San Mateo County Board of Supervisors Meeting

File Numbers: **PLN2001-00080**

FINDINGS AND CONDITIONS OF APPROVAL

Subject: Appeal to Proposed Subdivision (PLN2001-00080)

STORM DRAINAGE
 EXHIBIT-II, FILL IMPORT

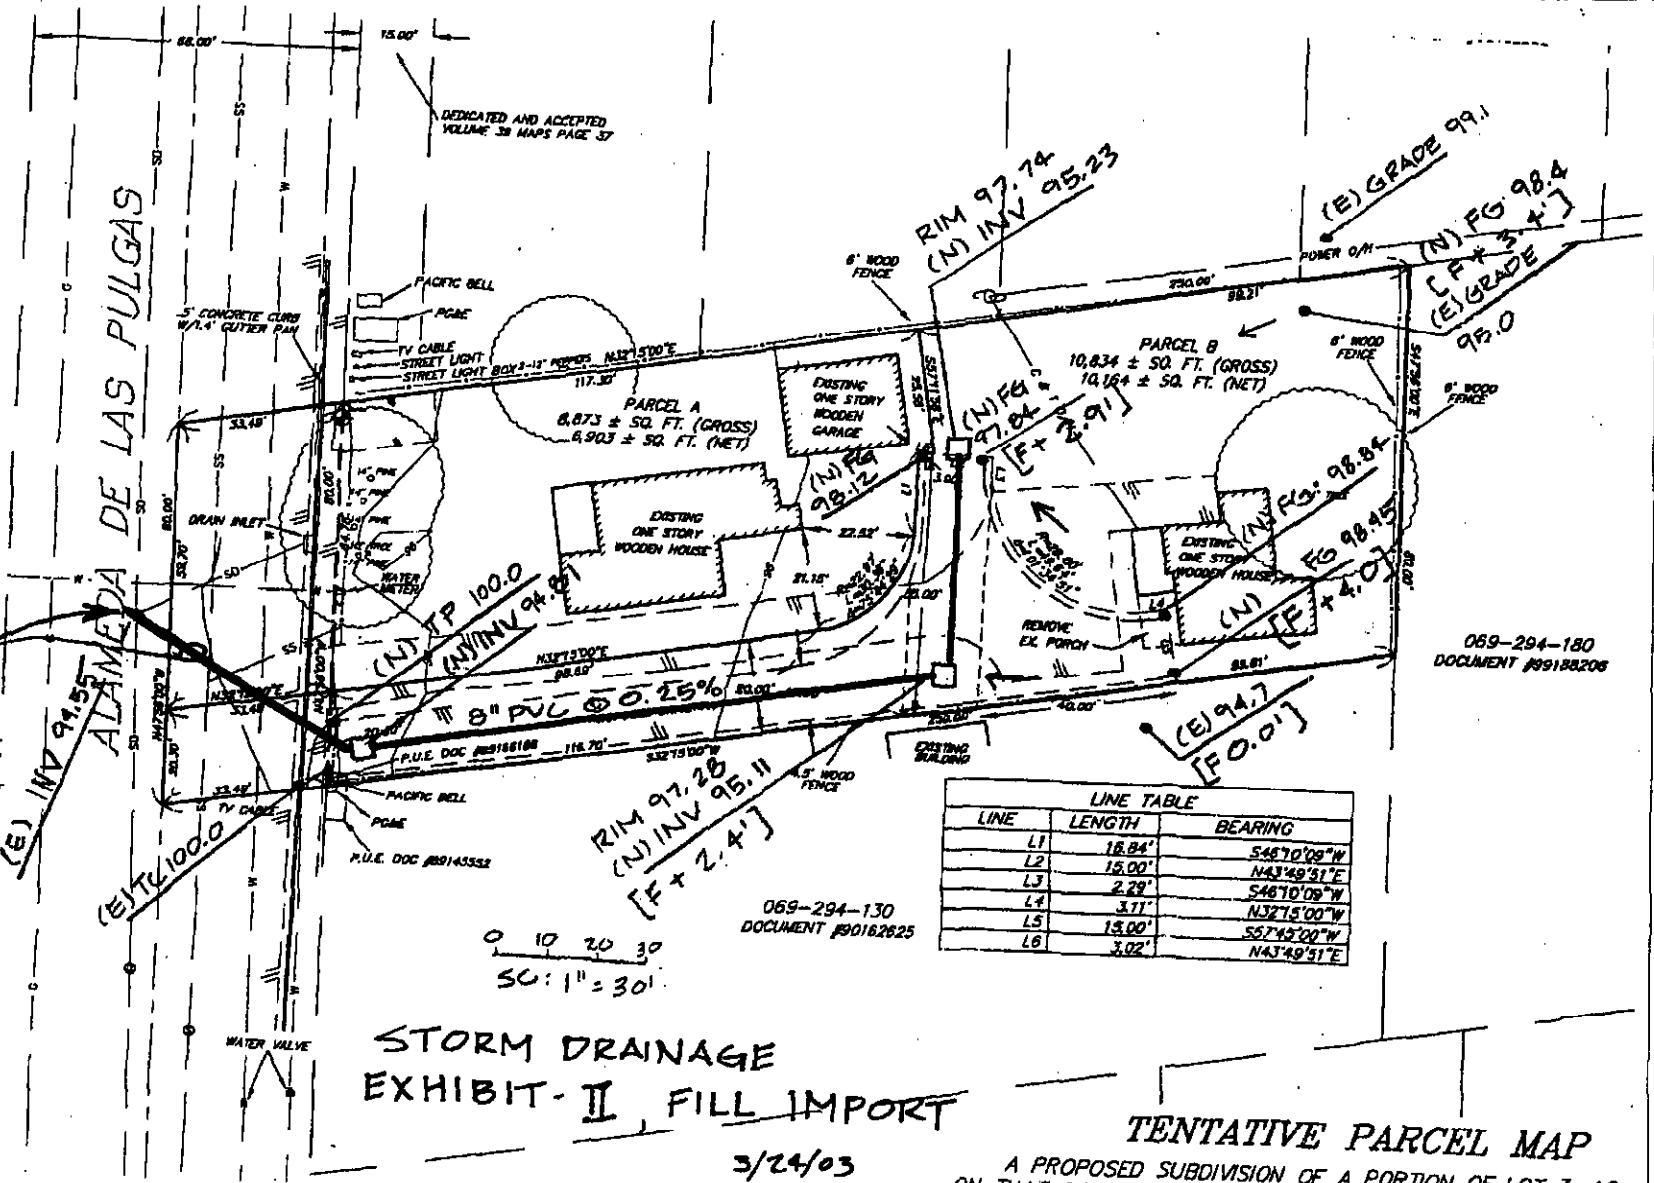
Another proposal (Storm Drainage Exhibit II) is to raise the level of the ground by infilling the parcel with up to 4 feet of soil. By raising the parcel, the developers will impact my solar photovoltaic system. This will allow them to infill 4 feet of soil and still build a 36 foot tall structure on top of it.
